Service-Information Motorcycle

34 011 86
(2230)

Squealing from Drum Brakes - R65's, R80's - 1985 and Later, and K75's

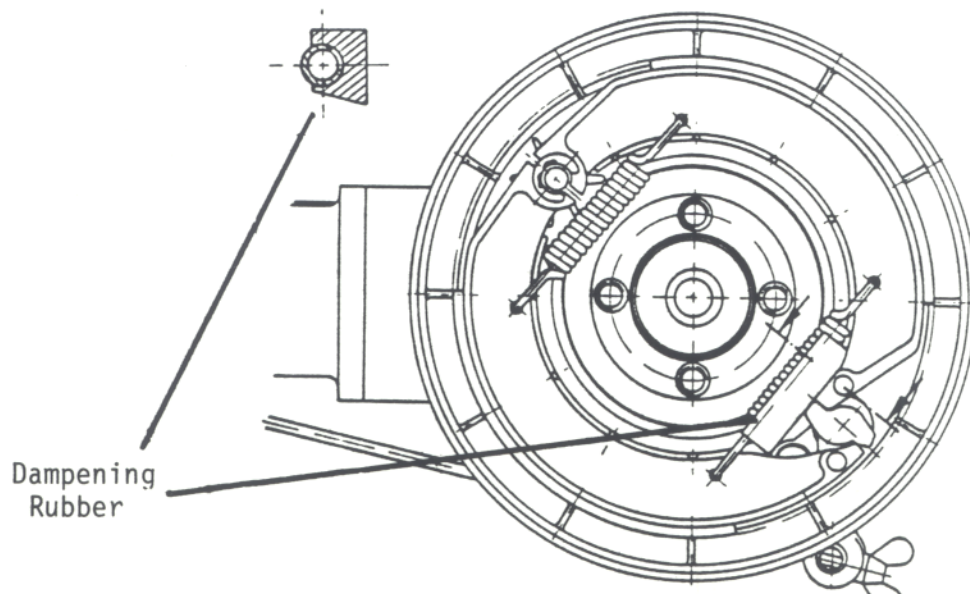
- COMPLAINT: Squealing noise from rear drum brake when brake is applied.
- REASON: The squeal is caused by the return spring vibrating. Depending on the intensity of the vibration, this squeal can be annoying.
- REMEDY: Installation of a dampening rubber around the brake spring at the Brake Shoe Pivot will dampen the vibration and the squeal noise will be minimized.
- PARTS: There are two (2) different size dampening rubbers:
1. K75 with sand cast brake shoes
Use Part No. 34 21 1 457 602 - 55mm long
 2. K75 with pressure cast brake shoes
Use Part No. 34 21 1 457 572 - 70mm long
 3. R65, R80 and R80RT
Use Part No. 34 21 1 457 572 - 70mm long

INSTALLATION: The rubber damper is installed only onto the rear brake shoe return spring. The flat side of the rubber rests against the brake shoe and pivot cam, with the slanted side facing the rear wheel (facing the left).

IMPORTANT: When installing this rubber damper, also **change both brake springs**.
